**Ivanhoe Estate Redevelopment Concept – development application (SSD 8707)**

**ATTACHMENT 1 - TABLE OUTLINING ISSUES WITH REVISED CONCEPT DEVELOPMENT PROPOSAL/ RTS – SSD8707**

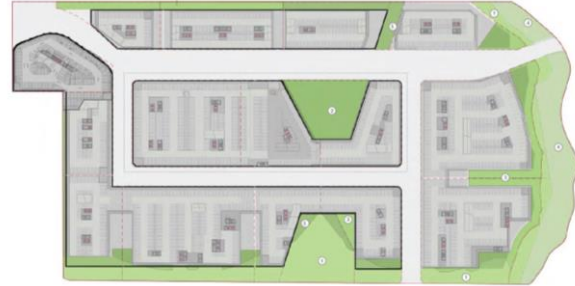
NUM	ISSUES PREVIOUSLY RAISED By COUNCIL (23/5/2018)	REVIEW OF REVISED PROPOSAL & APPLICANTS RESPONSE TO ISSUES	OUTSTANDING MATTERS WITH REGARD TO THE REVISED CONCEPT PROPOSAL: COUNCIL OBJECTION MAINTAINED AS PER MATTERS BELOW
		<p>council objecting to the removal of any within the EEC impact zone.</p> <p>Noted are the 'polygon' areas in the first submission that failed to individually identify and count trees within both polygon A and B which now, with setbacks will retain some of these. It would seem that 119 additional trees would be saved. However it is not clear in the report how this number is derived since the number of trees proposed for removal is still approximately the same.</p> <p>Also proposed is planting of 'Forest Park' to the adjoining STIF EEC to 'maintain and strengthen' the biodiversity corridor through species selection that is complementary to the community.</p>	<p>site (adjacent to 137-147 Herring Road) be retained. This will ensure contiguous vegetation for ecological integrity of the threatened ecological community.</p> <ul style="list-style-type: none"> <li>• The trees located between Buildings D2 &amp; D3 along Epping Road should also be protected. Thus the basement needs to be further setback in line with the location of existing vegetation.</li> <li>• Arborists Report has picked up additional 117 trees that were previously unaccounted for. The methodology used for tree survey is highly questionable. It is still difficult to quantify/locate the exact number of trees that are newly 'being retained' versus those which were (as admitted in the Arborists Report) mistakenly counted or not counted entirely in the first submission. For this reason Council does not have faith in the final numbers claimed for retention under the new submission. The new submission continues to not include the full extent of the polygon A &amp; B areas despite species in these areas forming part of the STIF community. Area A is located along the northern boundary and Area B is located along the common boundary of 137 Herring Road site. All trees located in Polygon A and B will be subject to high impact and are proposed for removal;</li> <li>• Arborists Report states that an additional 119 trees will be saved but falls short of stating where these additional trees are located. A review by City of Ryde indicates that out of the 119 trees, 117 trees are those that were previously unaccounted for and all of the 117 trees will be removed since they are located in Polygon A &amp; B. Arborist Report indicates that a total of 350 trees will be retained (an increase of 119 trees from previously 231 trees); Based on the above it is not clear how it can be claimed that an additional 119 trees would be retained.</li> </ul>

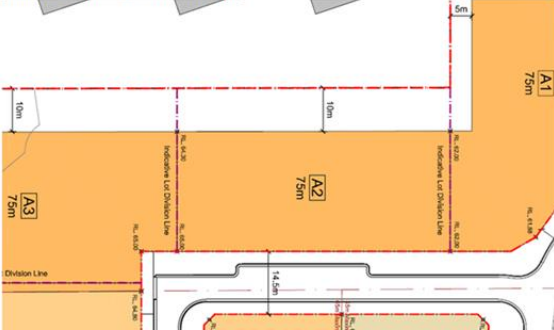
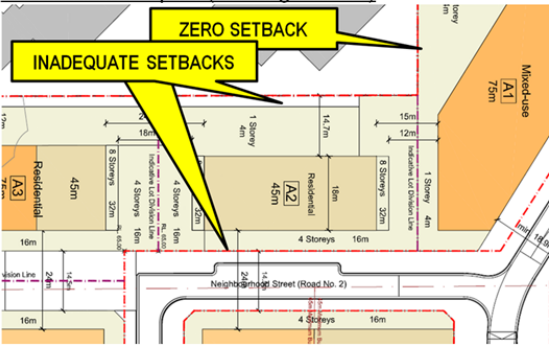
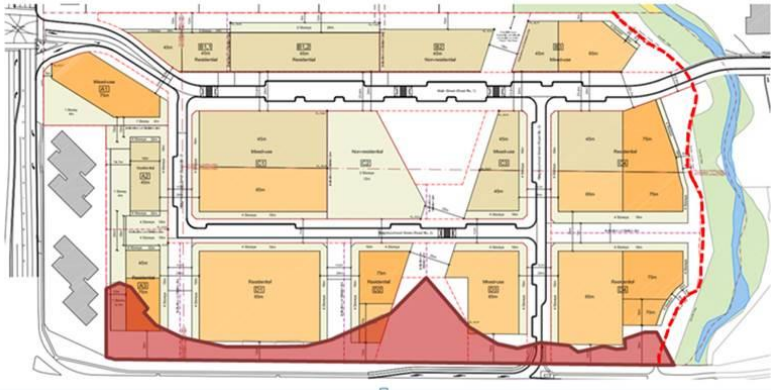
8	<p><b>Floor Space Ratio (FSR)</b> RLEP2014 FSR: 2.90:1; Bonus (ARHSEPP): 0.42:1 TOTAL Permitted: <b>3.32:1</b> (261,217m<sup>2</sup>) TOTAL Proposed: 3.60:1 Exceeded by: 0.28:1 or 22,283m<sup>2</sup></p> <p>The proposed gross floor area (GFA) and subsequent environmental impacts were raised as an issue by both the Department and Council. City of Ryde had objected to the significant breach in FSR.</p>	<p><b>Proposed:</b> RLEP2014 FSR: 2.90:1; Bonus (ARHSEPP): 0.42:1 TOTAL Permitted: 3.32:1</p> <p>TOTAL Proposed: 3.53:1 Exceeded by: 0.21:1 or 16,783m<sup>2</sup> (reduced by 5,500m<sup>2</sup>)</p> <p>Further issues identified in the current proposal are that the documents show a range of floor spaces for some buildings. For example the gross floor space of the school is shown as 7,000m<sup>2</sup> to 12,500m<sup>2</sup>. Does this mean that the GFA will not be locked in for each proposed lot. It</p>	<p>It is evident that the proposed density is excessive and beyond what the site can appropriately accommodate and as a result it is City of Ryde's position that any proposed variation to the FSR standards cannot be supported from an urban design standpoint. Refer to further discussion under "Design Issues" included in this table.</p> <p>This matter still remains unsatisfactory. There is a need for further reduction in FSR in light of concerns regarding various non-compliances, excessive loss of trees, excessive bulk &amp; scale and overdevelopment of the site. In Council's view the arguments presented in the Clause 4.6 Submission in support of this overdevelopment are not well founded.</p> <p>Applicant should clarify this matter.</p>

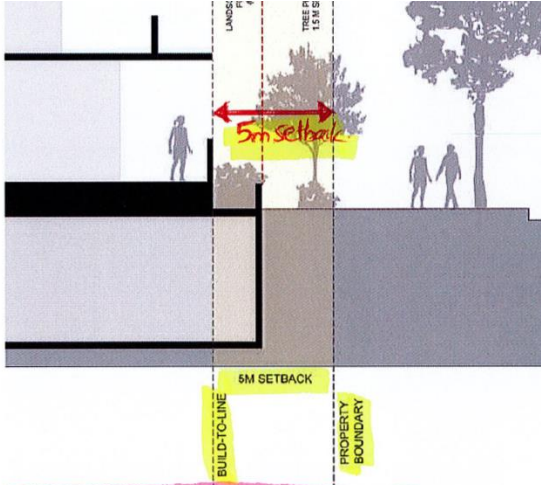
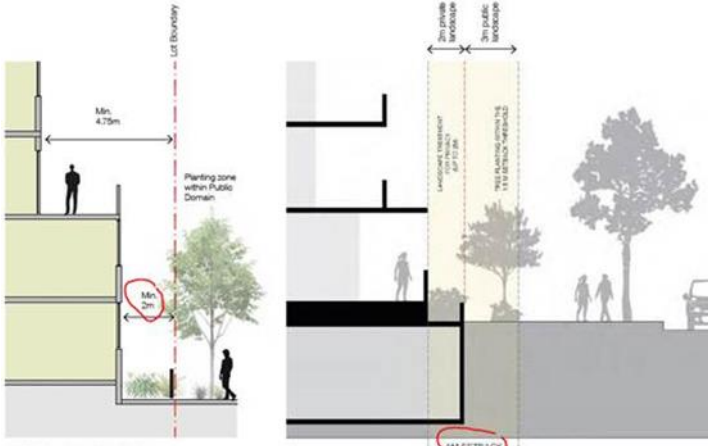
NUM	ISSUES PREVIOUSLY RAISED By COUNCIL (23/5/2018)	REVIEW OF REVISED PROPOSAL & APPLICANTS RESPONSE TO ISSUES	OUTSTANDING MATTERS WITH REGARD TO THE REVISED CONCEPT PROPOSAL: COUNCIL OBJECTION MAINTAINED AS PER MATTERS BELOW
	<p>137-143 Herring Rd. Building footprint was partly dictated by the need to protect a number of trees on that site and also on the western side of the Ivanhoe site.</p> <p>The plans show a setback/ separation on only 10m from the adjoining site.</p>	<p>streetscape other amenity impacts on individual buildings. This type of design is not consistent with the type of buildings that Council has approved on the adjoining site at 137 Herring Rd.</p> <ul style="list-style-type: none"> <li>○ In addition the setback of these buildings are not adequate along its north western side (estimated at 2m on the plan that has not been dimensioned).</li> <li>○ The building wall and basement on some parts are proposed right up to the boundary of the adjoining site. This will have additional impact on the trees located on the western side of the site, that is, required to be protected. Original scheme showed a clear 10m setback (which was not adequate and Council had requested that this setback be increased).</li> <li>○ Building A1 has zero setbacks from all of its boundaries, including zero setback from adjacent lot, zero setback to Building A2, zero setback to proposed new 14m road and zero setback to majority of proposed 20m wide road;</li> <li>○ The proposed roads does not comply with the width required under RDCP2014, that is, 14.5m and 20m;</li> <li>○ Setbacks</li> <li>● Setbacks along north western side of the site has not been improved. In fact it has been made worse of by further reducing the setback and in some places buildings are proposed on the boundary with zero to 2m setbacks as shown in the comparison diagrams below.</li> </ul>	<p>‘zero’ to 2m and is deemed inadequate. The building wall and basement on some parts are proposed right up to the boundary of the adjoining site. This will have additional impact on the trees located on the western side of the site, that is, required to be protected. Original scheme showed a clear 10m setback (which was not adequate and Council had requested that this setback be increased). The setback should be increased to at least 12m from the boundary including the basement and podium level to establish a deep soil zone and retain the contiguous trees that joins with the Epping Road Corridor;</p> <ul style="list-style-type: none"> <li>● The setback of 12m - 18m from Epping Road is inadequate. The built forms, basement parking and podium must not be located within the EEC corridor and existing landscaped area along Epping Road.</li> <li>● The built forms, basement parking and podium must be increased along Epping Road with respect to Building A3, D1 &amp; D2 to remain clear of the EEC corridor and existing landscaped area along Epping Road. City of Ryde seeks that this setback should range from 18m to 42m;</li> <li>● The built forms, basement parking and podium must not be located within the Riparian Corridor – see red dashed line in figure below:</li> </ul>

*Epping Road Setback diagram – Built form and basement parking must not be located in the red hatched area*

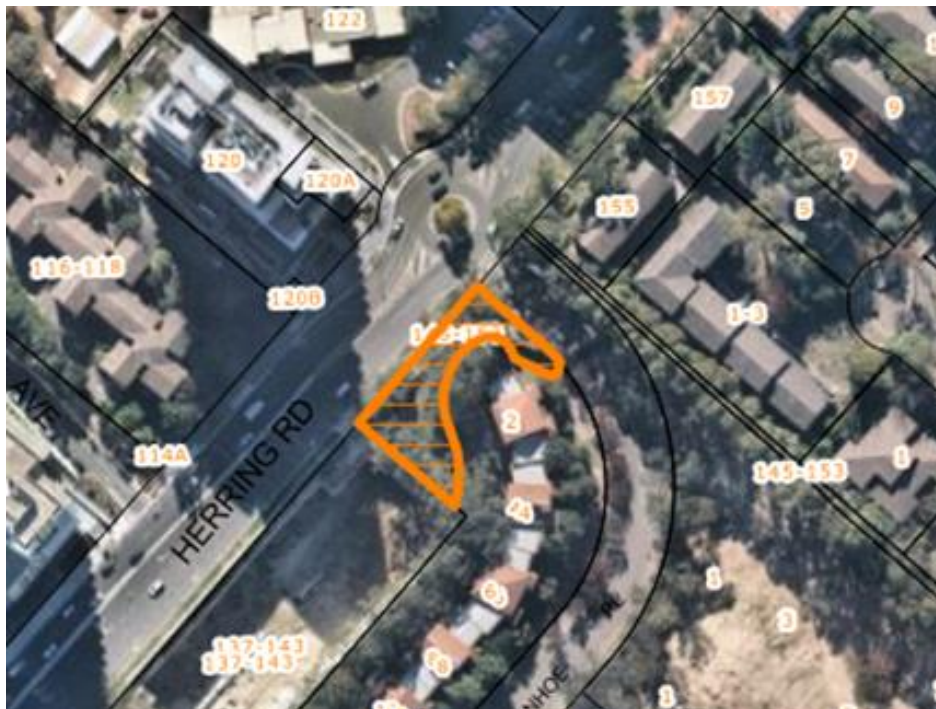
- (d) Council seeks that the building and basement setback along Epping Road be increased to reflect the general location of significant vegetation along Epping Road. Such a setback must be in the vicinity of 18-42m along Epping Road, generally reflecting the location of the trees and as per the area shown shaded red in the basement plan below which is based on Endangered Ecological Corridor:

**Setback from Herring Road – Built form and basements should not encroach on Lot 11 DP861433 shown hatched**

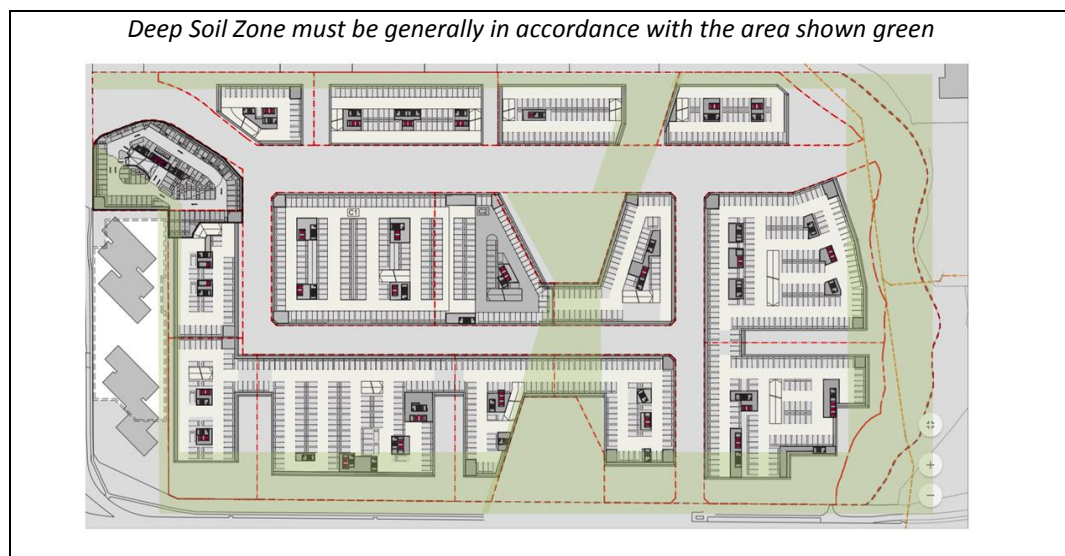
- (e) Trees located on Lot 11 DP861433 & north western end of the site (adjacent to 137-147 Herring Road) be retained. This will ensure contiguous vegetation for ecological integrity of the threatened ecological community.
- (f) Setback from Herring Road – There are a number of significant trees located on 154A Herring Road site (this site falls part of Ivanhoe Estate redevelopment). These trees will be affected by the zero setback proposed for Building A1 (also subject of Stage 1 development). These trees must be retained thus requiring additional setbacks to be provided in accordance with condition below. The trees are show in the diagram below:
